## COMMITTEE OF EXPERTS ON THE TRANSPORT OF DANGEROUS GOODS AND ON THE GLOBALLY HARMONIZED SYSTEM OF CLASSIFICATION AND LABELLING OF CHEMICALS

Sub-Committee of Experts on the Transport of Dangerous Goods  
Twenty-fourth session  
Geneva, 3-10 December 2003  
Item 3 (c) of the provisional agenda

#### Manual of Tests and Criteria, Appendix 5, Example of a test method for vent sizing

Transmitted by the International Council of Chemical Associations (ICCA)

**Figure A5.1: 10 LITRE VESSELS FOR VENTING TESTS**

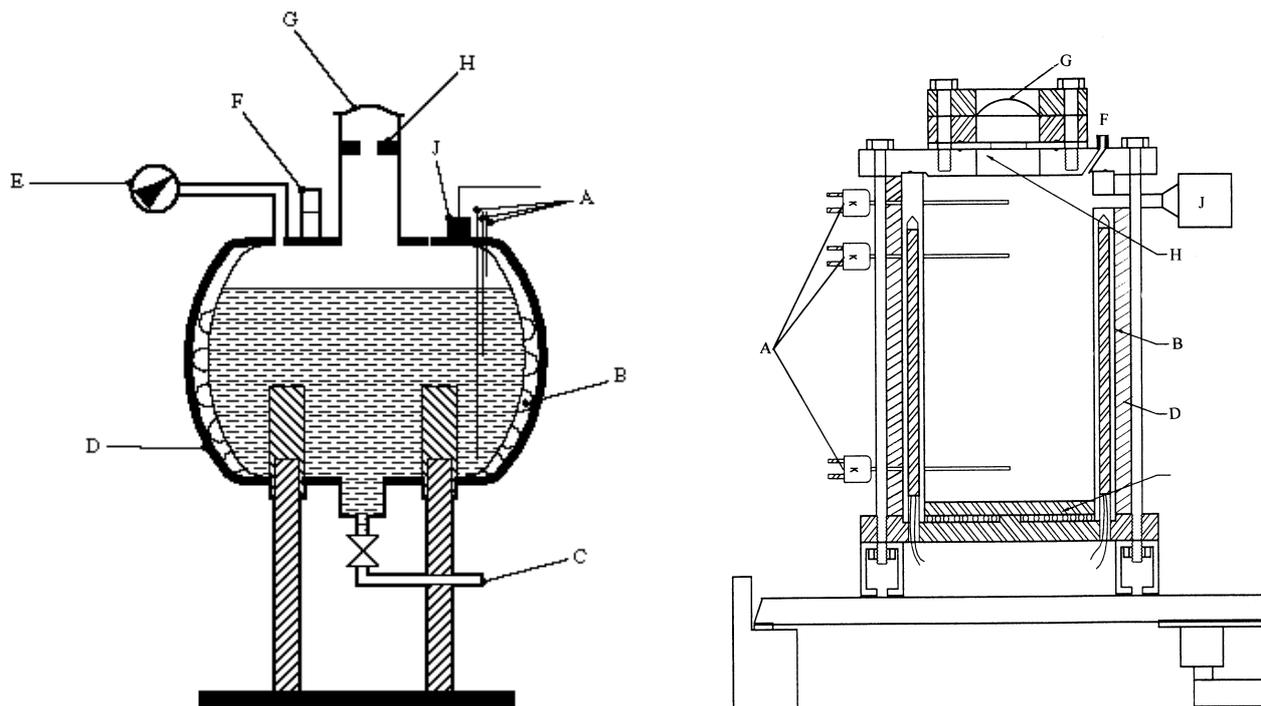
- In the USA, the Organic Peroxide Producers Safety Division (OPPSD) of the Society of the Plastic Industry, Inc. (SPI), developed in cooperation with New Mexico Institute of Mining and Technology, New Mexico, an alternative 10 litre test vessel which in principle is equivalent to the test method as currently in the Manual of Test and Criteria, and

- Inclusion of a reference to the applicability of the test method for IBCs, criterion for maximum acceptable pressure allowed during emergency venting of IBCs and addition of calculation example for IBCs,
- Inclusion of test vessel as developed by OPPSD in corporation with New Mexico Tech, USA, and
- Correction of equations (1) and (3) and the calculation examples (extra brackets).

The reduced scale tank consists of a stainless steel test vessel with a gross volume of 10 l. The top of the vessel is provided with either a 1 mm opening which simulates the pressure relief valve (PRV) of the IBC or portable tank or a real PRV of a diameter which is scaled using the vent area to vessel volume ratio. A second opening simulates the emergency vent opening and is closed by a bursting disk. The diameter of this vent opening can be varied by using orifice plates with different apertures. The bursting pressure of the disk fixed to the 10 l vessel should be equal to the maximum rupture pressure of the bursting disks to be fitted to the IBC or portable tank. This pressure should be lower than the test pressure of the IBC or portable tank involved. Usually, the bursting pressure is set at a level that can cope with the pressures encountered during normal transport conditions such as hydrostatic pressure from the liquid due to turn over of the IBC or portable tank, slopping of the contents, etc. The 10 l vessel should be provided with a bursting disk with a set pressure in the range of the disk(s) fitted on the tank or IBC as to be used in transport. For safety, it is recommended to provide the test vessel with an extra bursting disk (bursting pressure approximately 80% of the design pressure of the 10 l test vessel) with a large opening for additional emergency venting of the test vessel in the event that the chosen orifice diameter is too small.
